DOC16/615962  
SSD 13 6277

**Jupiter Wind Farm Environmental Impact Statement (EIS) – OEH review**

## **Attachment 1 –Information on biodiversity impacts of Jupiter Wind Farm**

## Map 1

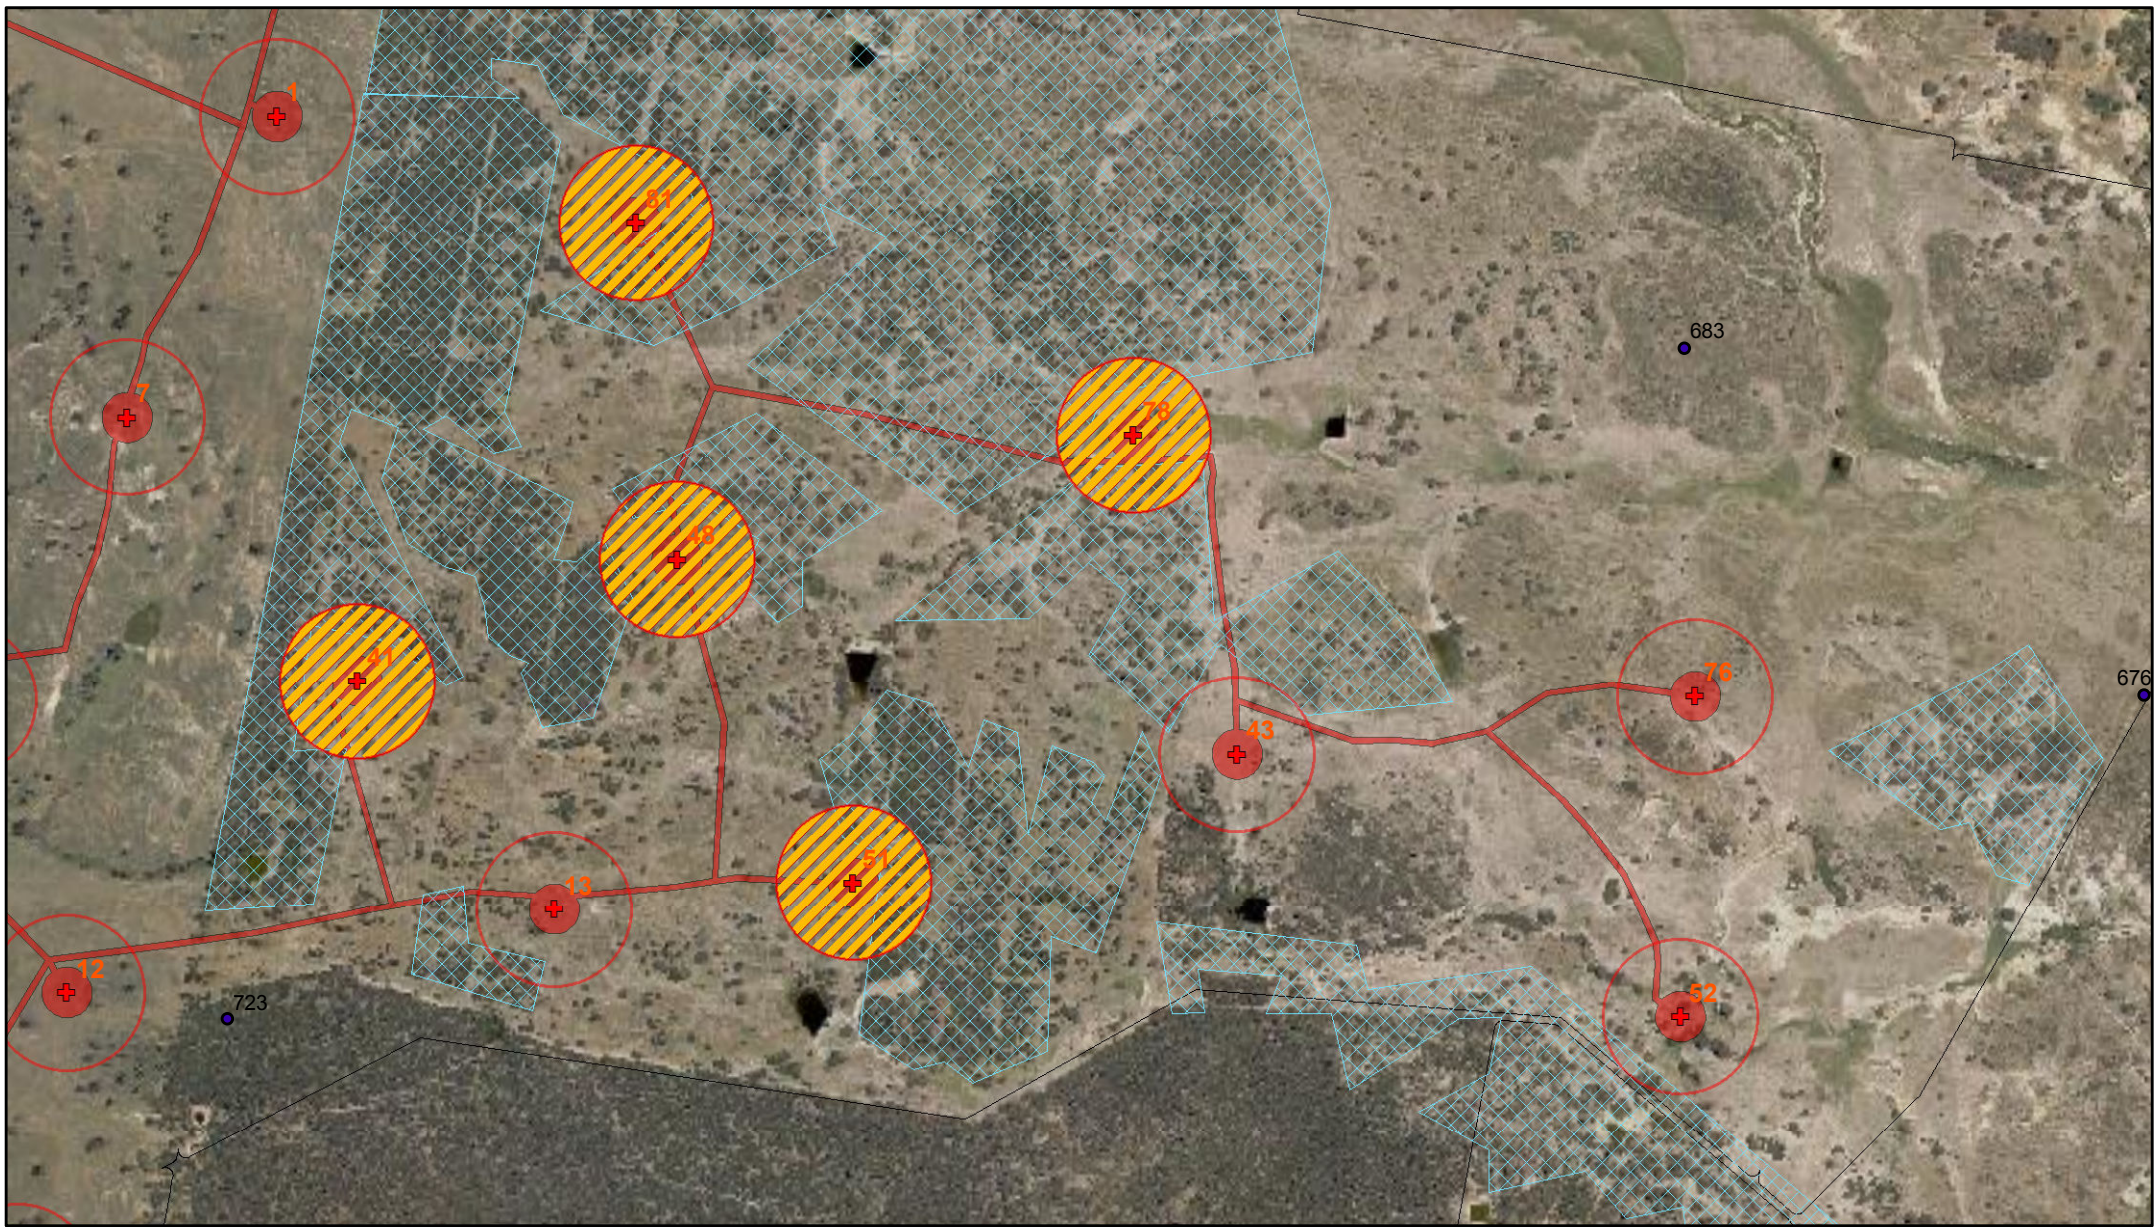
The EIS states that the project will have a significant impact on GBC. This is of great concern as this species is very rare in region. We therefore recommend the removal of turbines 41, 48, 51, 78 and 81 to avoid the removal of known foraging and known or potential nest trees (see Map 1). Turbines 13, 43, 52 and 76 could be constructed in this area of habitat, provided the construction of turbines, cables and roads does not result in removal of foraging habitat (*Allocasuarina*) or any trees with hollows greater than 15cm diameter.

## Map 2

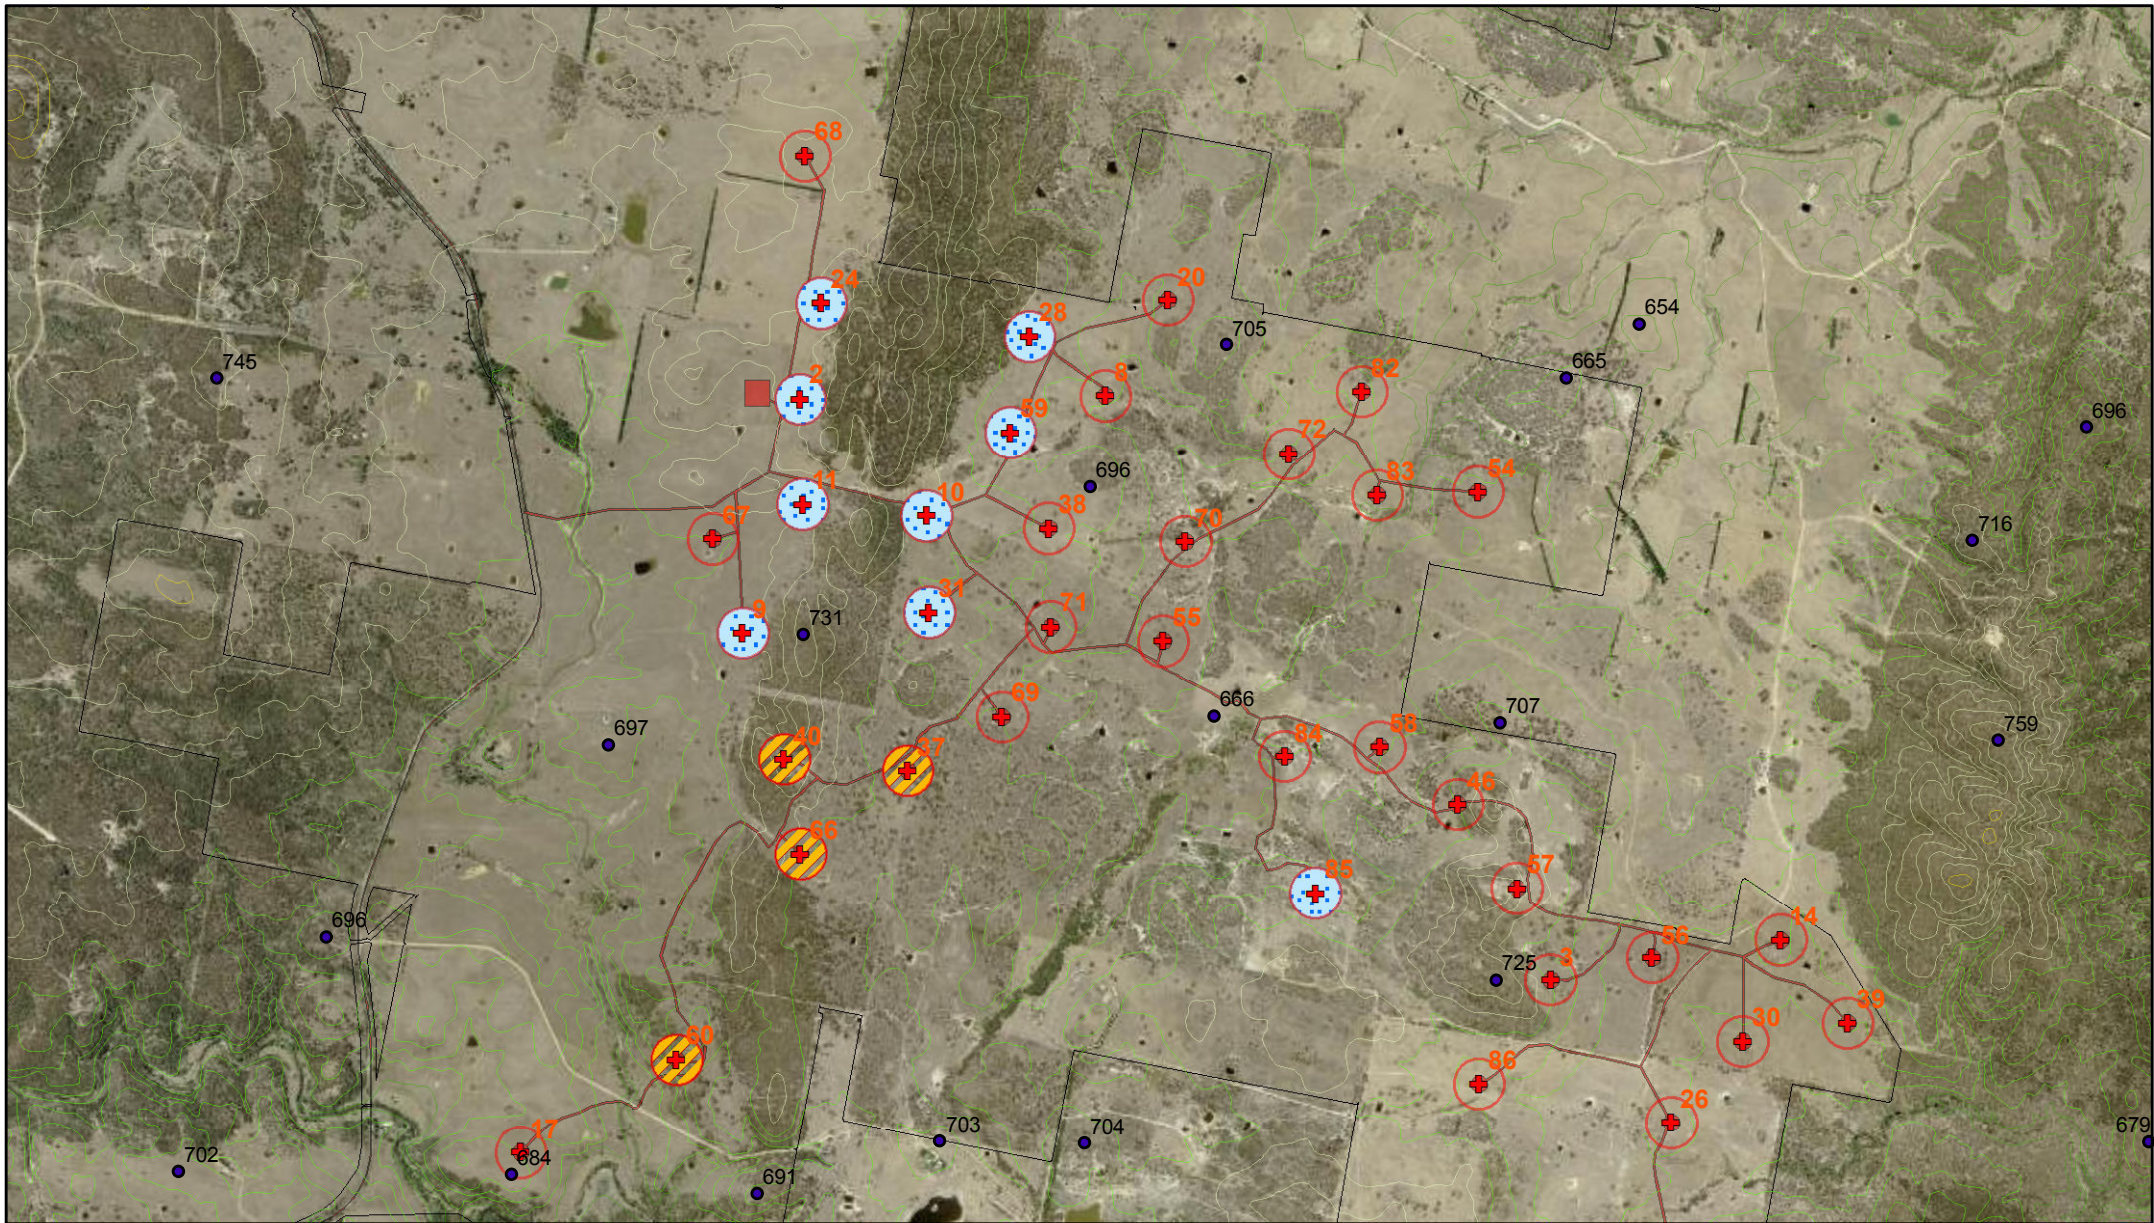
OEH recommends removal of turbines 37, 40 and 66 to protect the most significant stands of woodlands (see Map 2). This would have the additional benefit of protecting known Hoary Sunray habitat (see Map 5.6 from EIS Appendix D Biodiversity Assessment – reproduced here as Map 6). The Hoary Sunray is listed as Endangered under Commonwealth legislation.

Of particular concern are the turbines in the central cluster, along the western and eastern fringes of a forested ridgeline (Map 2). We recommend moving turbines 2, 9, 10, 11, 24, 28, 31 and 59 further back from the vegetation. Turbines 40 and 66 should be removed as they are located in the middle of the N-S remnant. This remnant open forest is in good condition and will provide important habitat for a range of threatened and other species, surrounded as it is by much lower condition vegetation and cleared farmland. Birds and bats utilising the ridgetop forest in this area, will fly from the treetops,

## Map 3

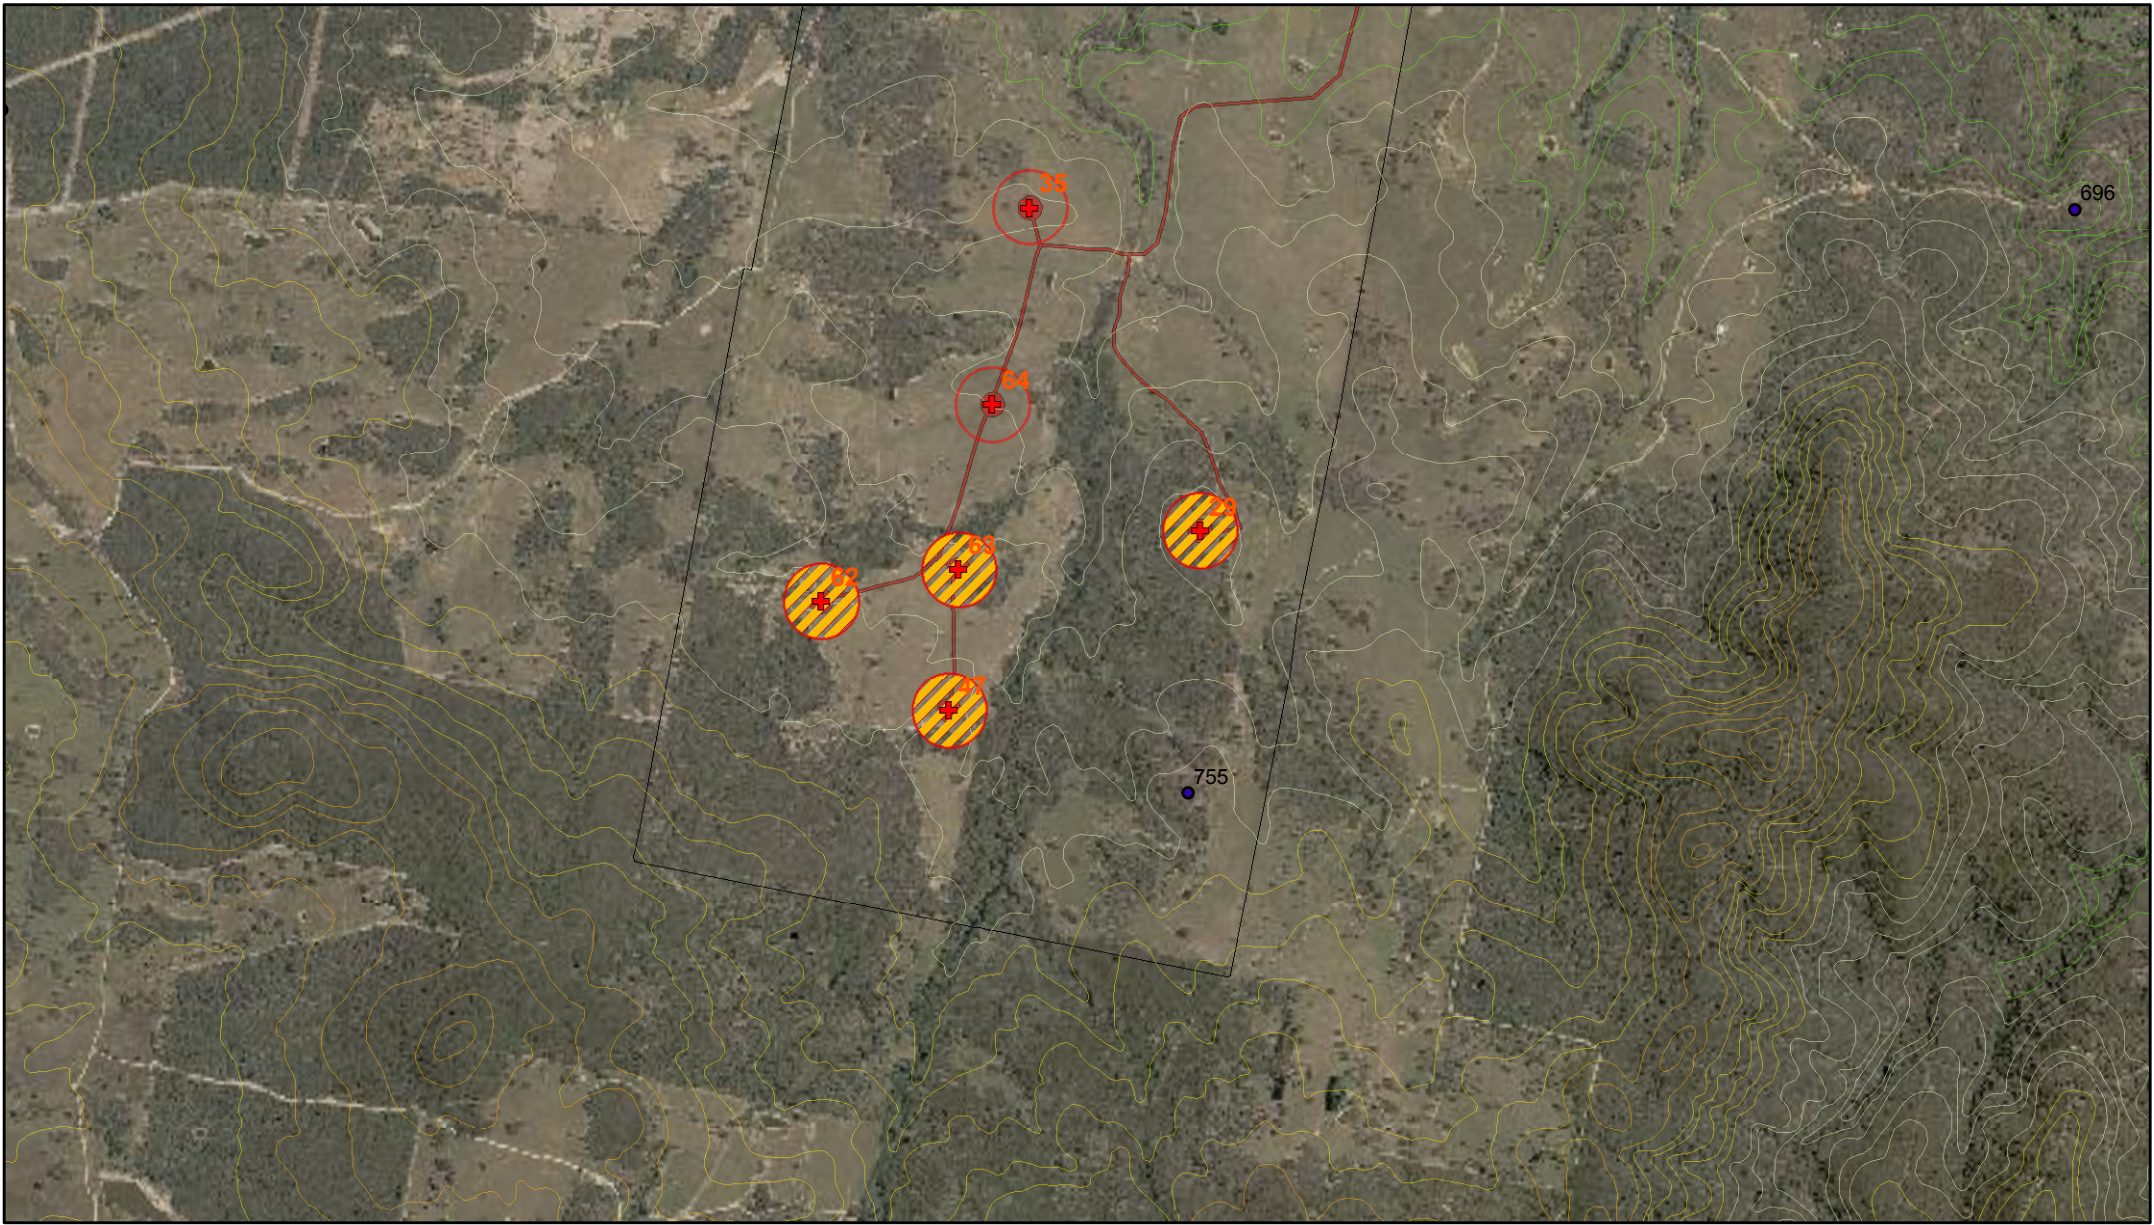
OEH considers that the turbines in the southern cluster will have an unacceptable impact on biodiversity values. These turbines are also located in a lower elevation area between forested ridges (100-200m higher), increasing risk of blade-strike (Map 3). Turbine 29 should be removed due to the proximity of threatened species and EEC. Turbines 47, 62 and 63 should be removed as they pose a high risk to birds and bats flying between adjacent forested hills through RSA. 64 and 35 are also likely to be high-risk turbines for threatened and migratory species moving between the surrounding patches of HCV vegetation – especially EBB.

## Map 7

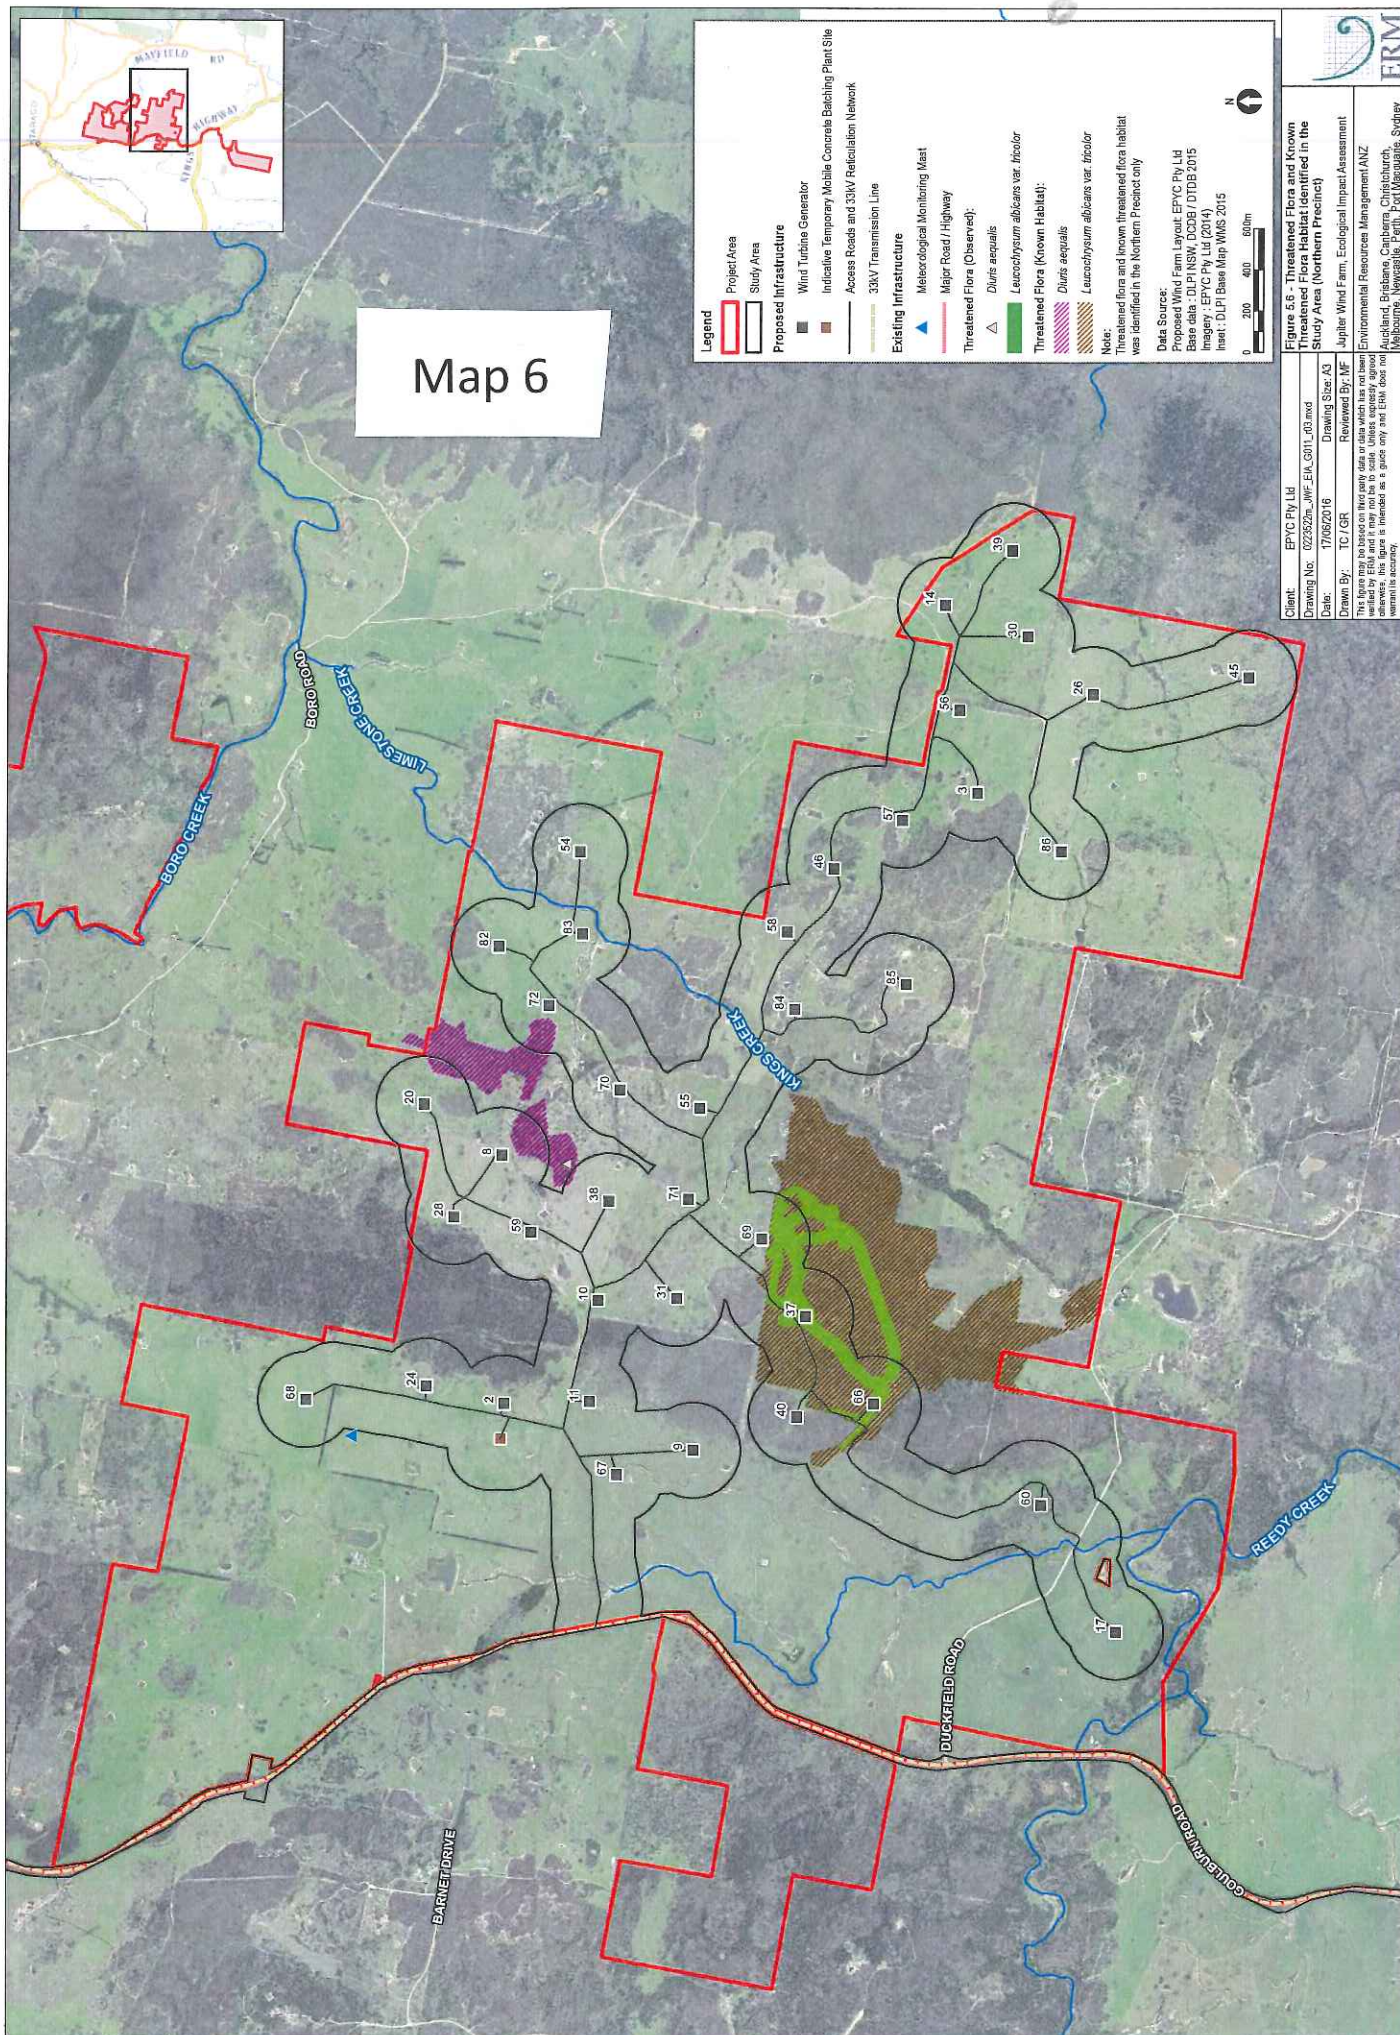
There are five wind farms within 50km of Jupiter, and a further 11 within 100km. There are close to 1,000 turbines operating or proposed within 100km, many of which are located on north-south ridgelines, like Jupiter (see Map 7).
